Response to Officer Queries No.3

Site: Horn Crag Quarry

Proposal: Reopening

Document Reference: 232/5/1—R1.1 V3 - 20230510

Appendix A
232m Cross Section

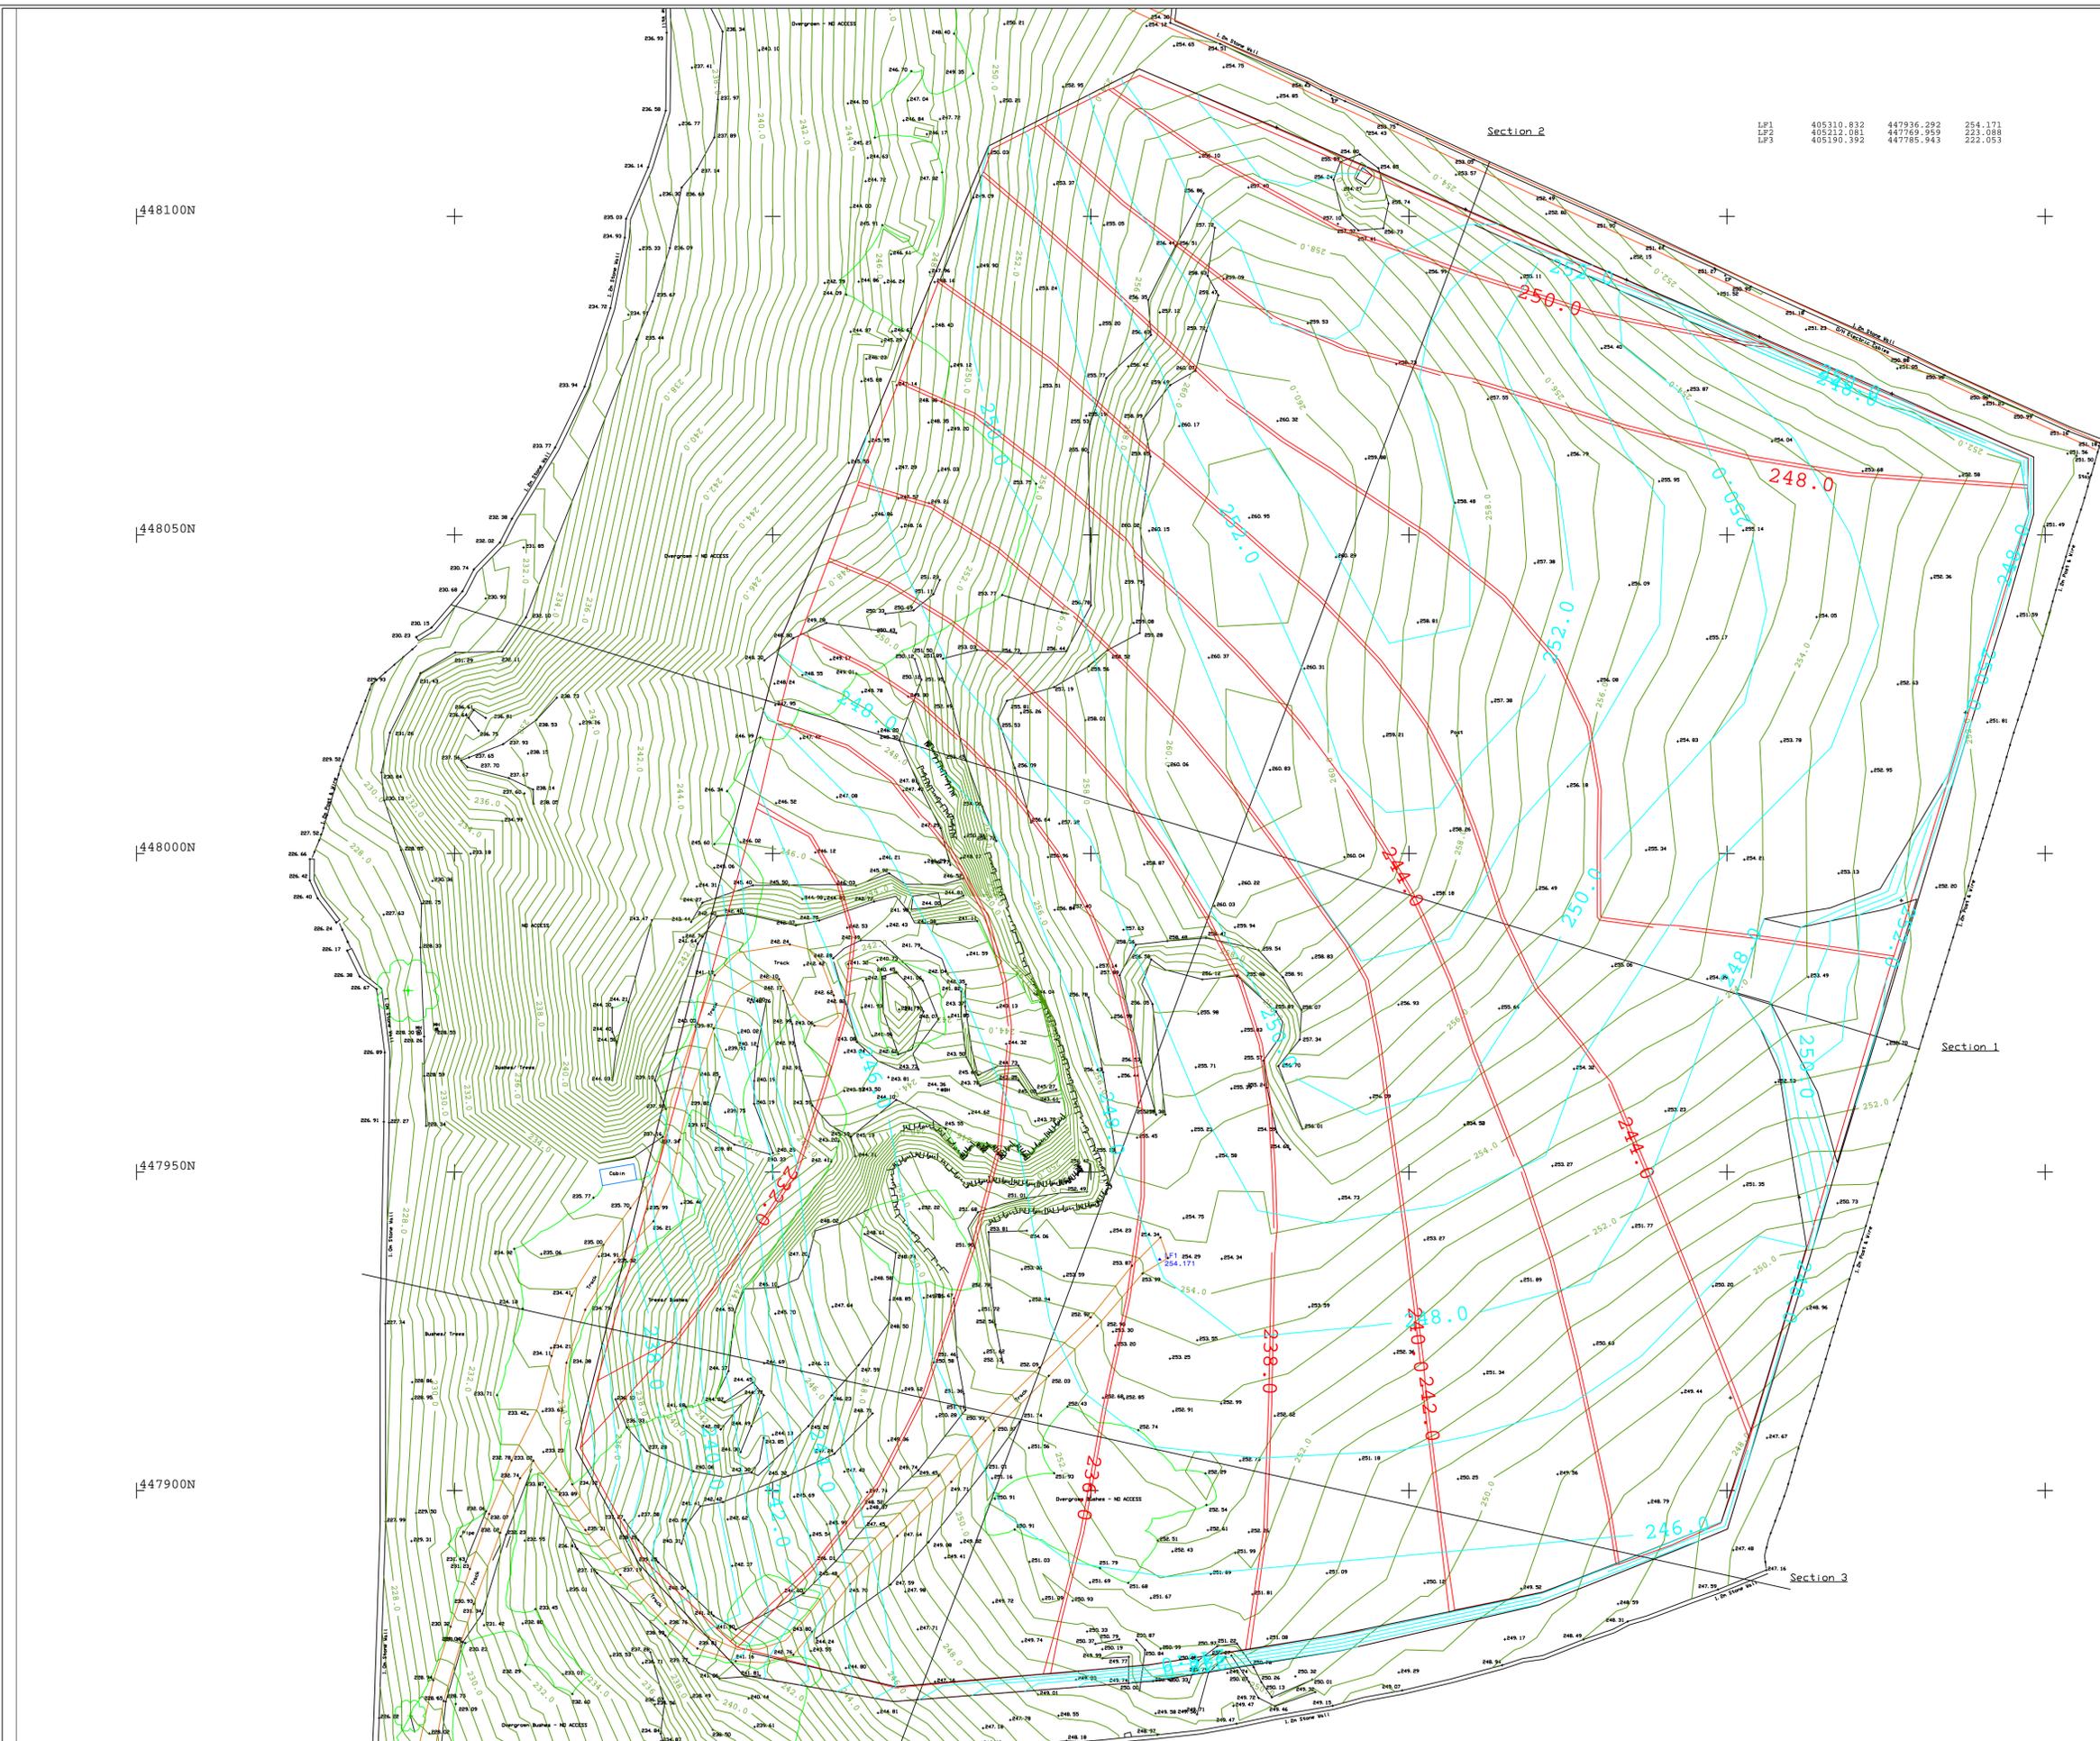
“Response of 27 April - Section 6.0. It is stated that the maximum depth is to be 232m as per Quarry Design plan ref: E454-003. It would be useful to have a cross section at the southern part of the site to reflect this maximum depth, as the current cross sections do not reflect this lower point of 232m, nor the 234m excavation contour line - the current cross sections give the impression that the maximum depth is 236m.”

- 2.1. Additional cross section attached at Appendix A.
